2/18/91	REVISED PER 27-01 MTS #020791	RM
2/13/91	REVISED PER 27-01 MTS #020791	RM
2/6/91	ADDED & REVISED PIPING	RM
NO. DATE	REVISIONS	BY
THE NEW BASEBALL PARK THE MARYLAND STADIUM AUTHORITY ARCHITECT: H.O.K. ENGINEER: KIDDE CONSULTANTS GEN. CONTRACTOR: HYMAN		
<b>PARKER-KIRLIN          JOINT VENTURE</b> MECHANICAL CONTRACTORS		
MAIN CONCOURSE PIPING LEVEL SLEEVING		
DATE: 12-7-90	DWG. NO.	
SCALE: 1/4" = 1'-0"	4A-2-202	
BY: [Signature]

NO.	DATE	ADDED PIPING, DRAINS & SWS.	REVISIONS	BY
1				
THE NEW BASEBALL PARK THE MARYLAND STADIUM AUTHORITY THE BALTIMORE ORIOLES				
ARCHITECT: H.O.K. ENGINEER: KIDDE CONSULTANTS GEN. CONTRACTOR: HYMAN				
PARKER-KIRLIN JOINT VENTURE MECHANICAL CONTRACTORS				
TITLE MAIN CONCOURSE PIPING CLUB LEVEL SLEEVING				
DATE: 2-2-91		DWS. NO.		
SCALE: 1/4"=1'-0"		40-272

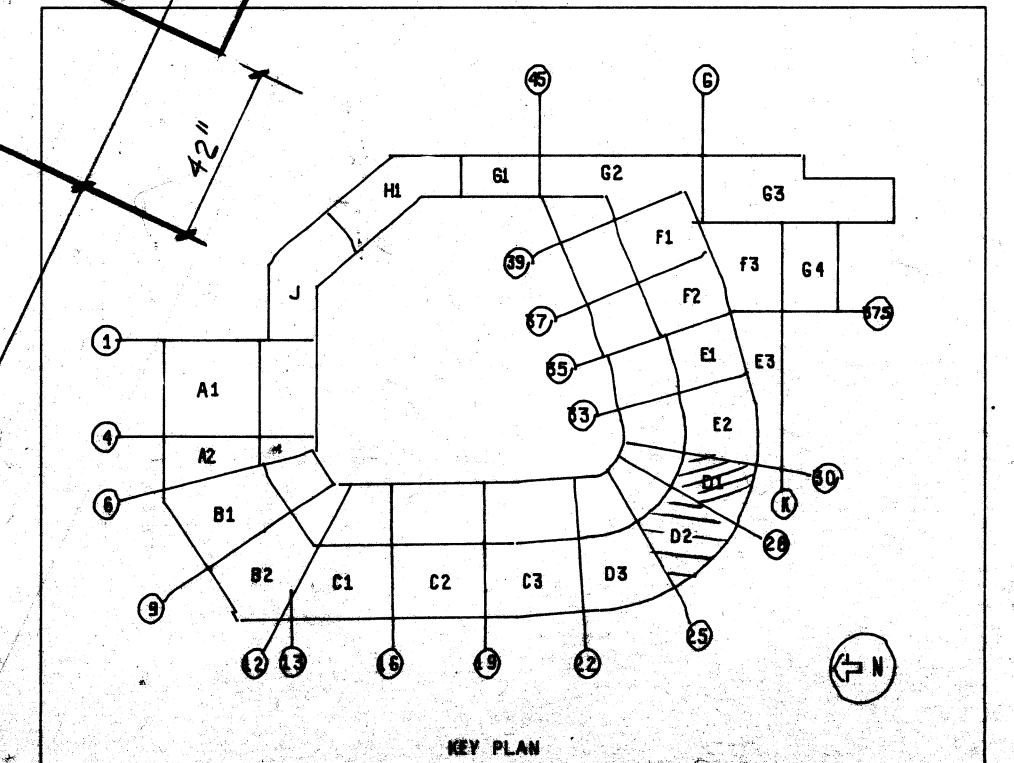
New 6" strainer  
(3/6" OSY  
New PRV and  
bypass

There is a  
PRV  
Station  
with  
bypass  
in  
this  
area

Work is  
above  
drywall  
ceiling

New 8" OSY - Flanged  
transition to 6"

New 8" OSY

Work is  
above  
with  
open  
ceiling

~404 ft of 4"  
~100 ft of 6"

6"  
New 6" OSY and drains on  
main after supply for WRR  
and prior to transition up onto  
roof

Work is  
above  
drywall  
ceiling

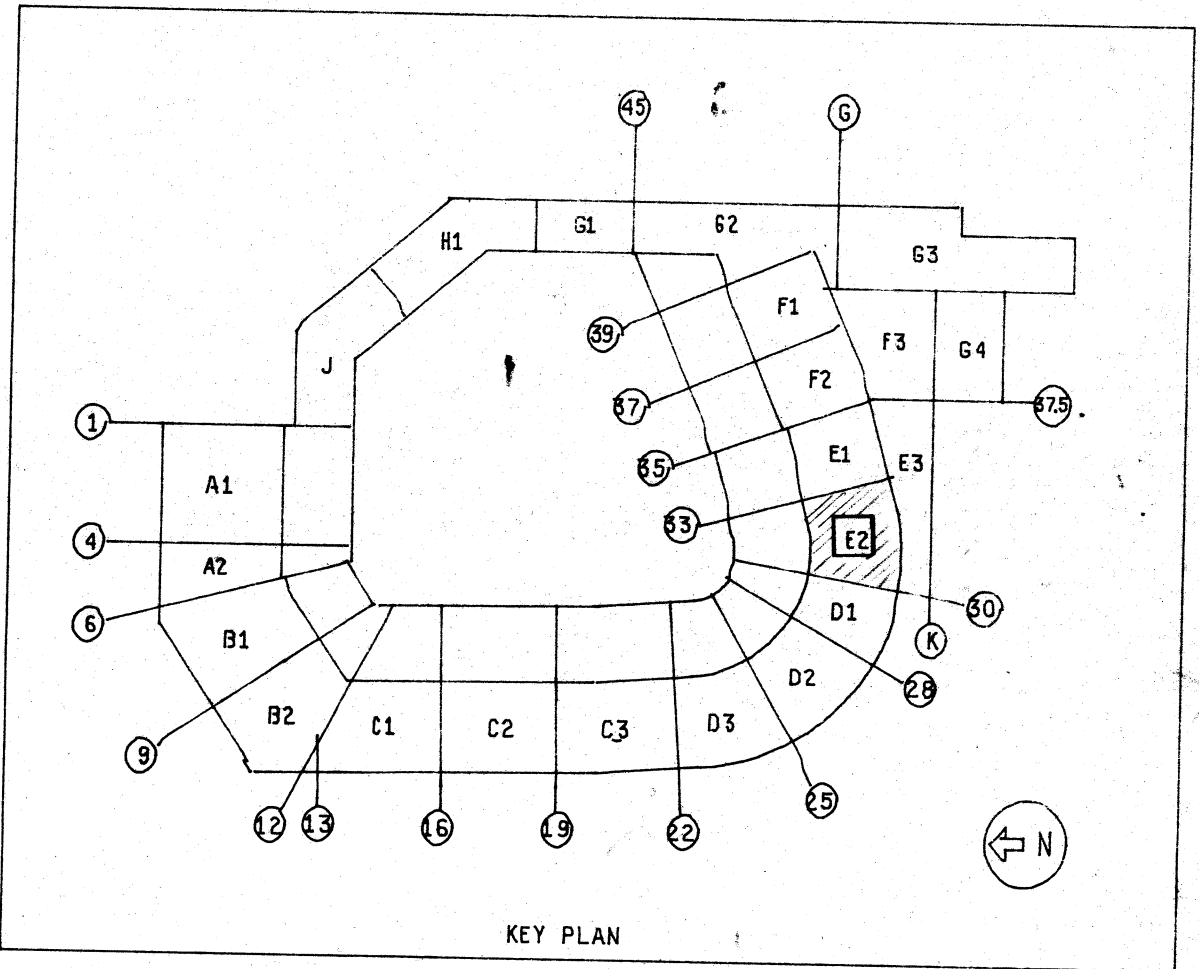
From this point forward all DCW main pipe is  
accessible from the rooftop until column 42.5

Minimal in wall work prior to  
transition of pipe to  
above the concession roof

6" transitioning  
to 4" after T for  
vomitory hose  
bib service

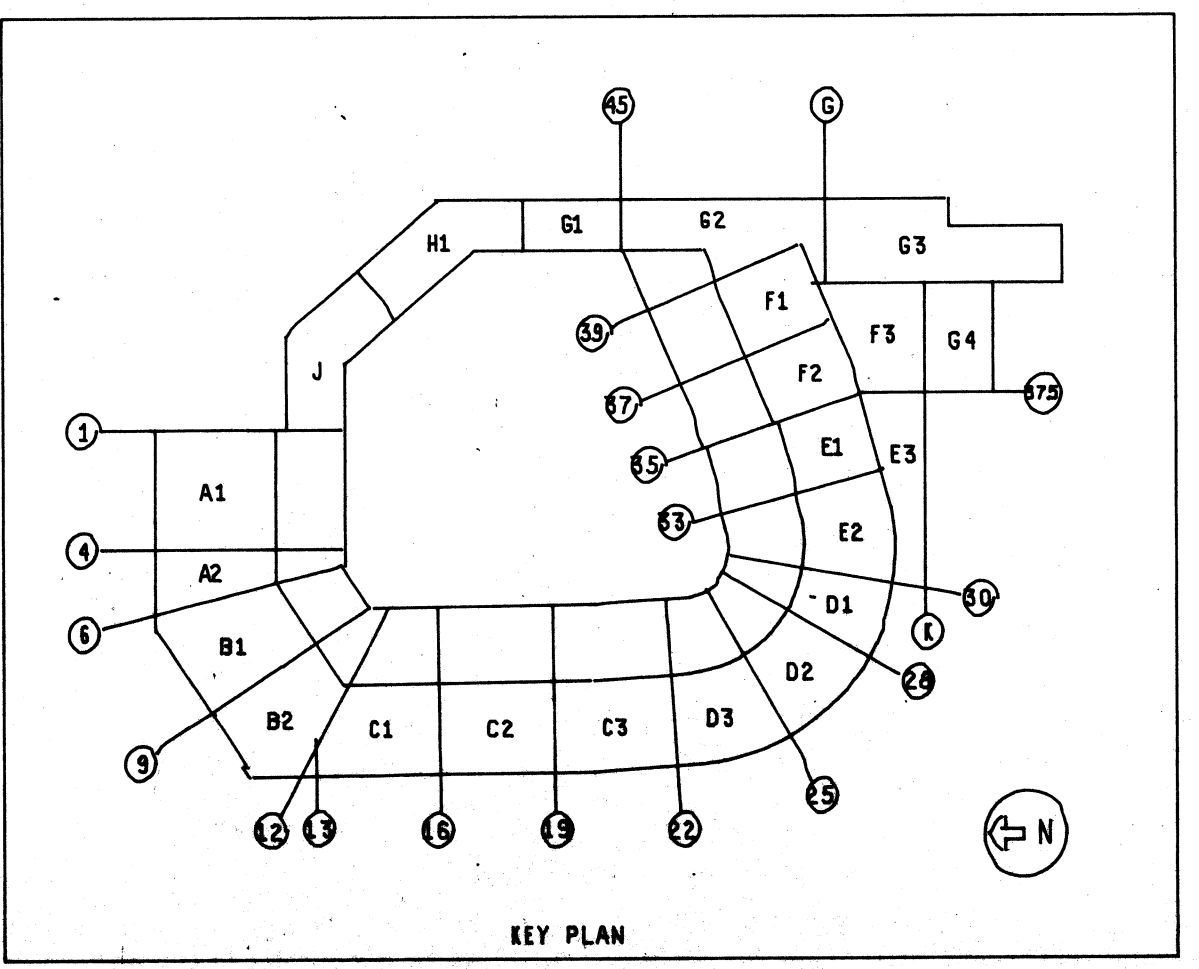
New 4"  
OSY
